MEMORANDUM

Date: May 3, 2023

RE: Centre Collective Preliminary Site Condominium Review (New

Configuration)

EXISTING CONDITIONS AND REMOVALS PLAN

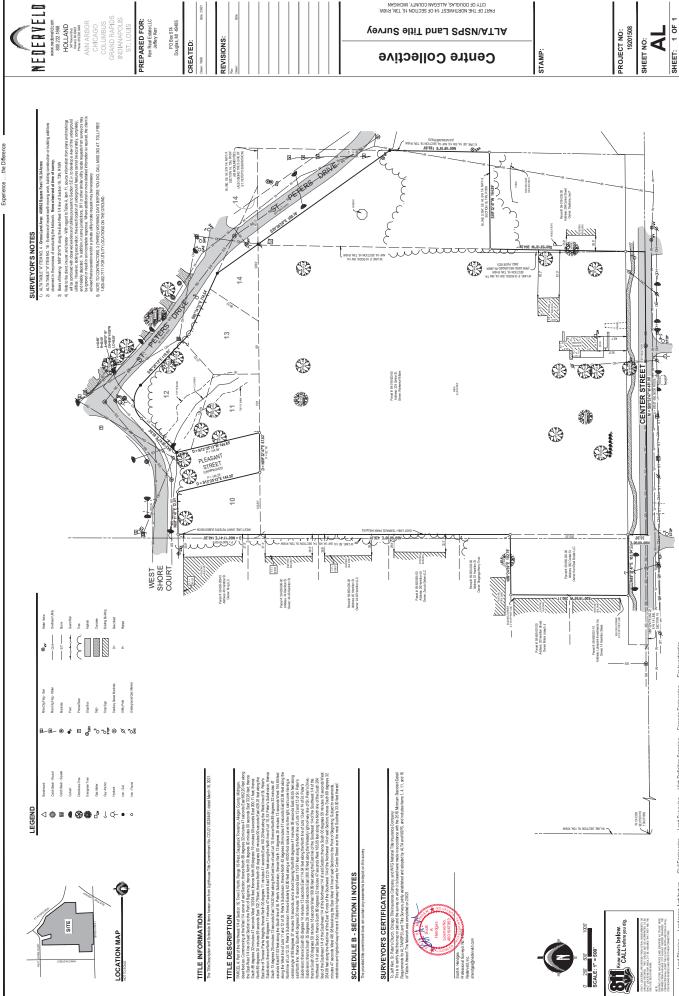
REMOVE: 75 LFT. - GUARD RAIL

CUL-DE-SAC & INTERSECTION PLAN

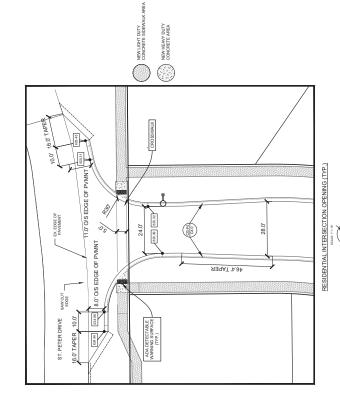
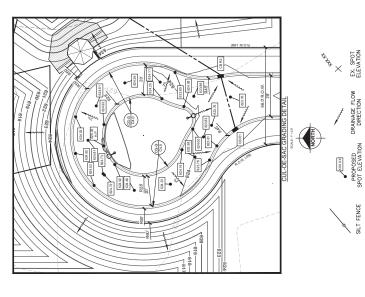
- 6. Road shall not exceed the 10% maximum grade. (IFC 503.2.7) **Approved, grade is shown as less than 10% in revised submittals on sheet C2.1.**
- 7. The driveway shall be installed with asphalt, concrete, or other approved driving surfaces capable of supporting the 80,000-pound imposed load of our heaviest apparatus and be installed to provide emergency access prior to commencement of building construction. (IFC 503.2.3) *Weight capacity is not noted in plans provided. Please include in revised submittals.*

- We submitted revised plans that illustrate the cul-de-sac geometry meets or accommodates the turning movements of the Saugatuck 49" truck.
